A long-term dataset of debris-flow and hydrometeorological observations from 1961 to 2024 at Jiangjia Ravine, China, [Paper # essd-2025-190]

Reply to reviewers' comments

Figure 7. Variation of sediment transported by debris flow recorded from 1966 to 2024. * denotes debris flows occurred without observational data.

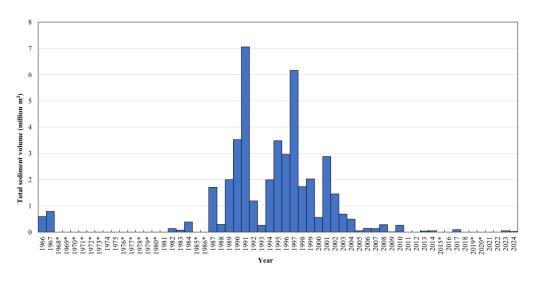
C1: In Figure 7, the sediment transported by debris flow shows considerable inter-annual variability. Could the authors clarify whether this level of variation is consistent with the actual field conditions, and if so, provide a reasonable explanation for these fluctuations?

R1: As shown in Figure 3, debris flows indeed occurred in 1968, 1969, 1970, 1971, 1972, 1973, 1976, 1977, 1978, 1979, 1980, 1985, 1986, 2015, 2019, and 2020. However, in these years, the debris flows did not reach the monitoring section, resulting in no observational data (these years are also annotated in Figure 7). Partial surge data are missing for the events in 1974 and 1975, and no total sediment transport data is available for these years.

Overall, the frequency and magnitude of debris flows have significantly declined in recent decades. However, the events in 2023 and 2024 still recorded significant sediment transport volumes of 52,682 m³ and 31,450 m³, respectively, which remain substantial for mountainous watersheds. By the way, we are currently analyzing the relationship between climate change and sediment transport, to reveal the key factors that control the declined rate of sediment.

We have added the description in the revised manuscript (Page 12, Line 273-276):

"Overall, the frequency and magnitude of debris flows have significantly declined in recent decades. However, the events in 2023 and 2024 still recorded significant sediment transport volumes of 52,682 m³ and 31,450 m³, respectively, which remain substantial for mountainous watersheds. The decreasing trend may be a result of climate change."

Figure 8. (b) the time-domain seismic signal and time-frequency characteristic curves of the debrisflow event on July 28th, 2024.

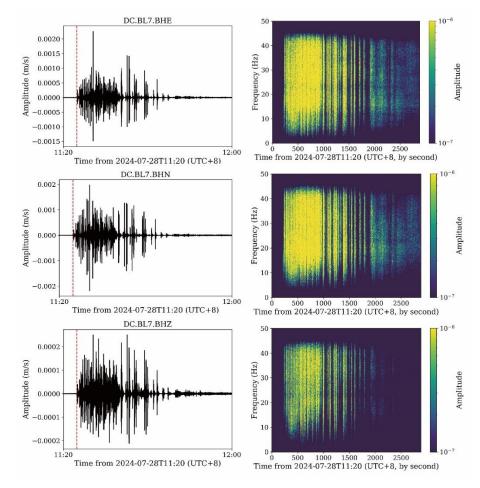
C2: The text in Figures 3 and 8b is difficult to read due to low resolution. It is recommended to improve the image quality and enhance the readability of the labels and annotations in these figures.

R2: Thank you for your suggestion. We have redrawn the figure as follows:

Accuracy validation of air temperature measurements and hourly rainfall measurements We have added this information in the revised manuscript (Page 25, Line 474-482):

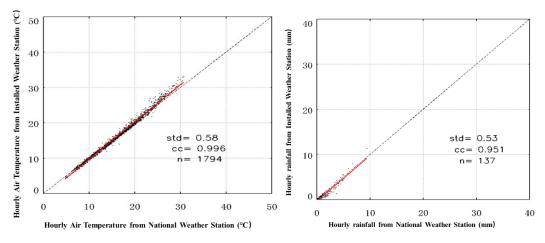
C5: Regarding data reliability, it would strengthen the manuscript if the authors could clarify whether any cross-validation or data consistency checks were performed to verify the validity of the long-term observations.

R5: Most datasets, including debris-flow kinematic data, particle size distribution of debris flows, rheological data of debris-flow slurry, cross-sectional measurement data, sediment concentration, grain size distribution data, and observation data from runoff plots, were obtained through manual observation. These data are considered to have relatively small errors. Additionally, we performed calibration and verification of rain gauges and weather stations in 2021. Some of the results are shown in the following figures, indicating high reliability.

"Most datasets, including debris-flow kinematic data, particle size distribution of debris flows, rheological data of debris-flow slurry, cross-sectional measurement data, sediment concentration, grain size distribution data, and observation data from runoff plots, were obtained through manual observation. These data are considered to have relatively small errors. Additionally, rainfall data from tipping-bucket rain gauges, collected prior to 2024, showed high reliability when cross-validated with data from regional national meteorological stations. In 2024, piezoelectric rain gauges and meteorological stations were installed and underwent performance verification at national benchmark sites before deployment. The correlation coefficients between these instruments and the reference data from national meteorological stations. **"C6**: There are still several language and formatting errors throughout the manuscript. For instance, in the caption of Figure 1, (c) is incorrectly labeled as (b).
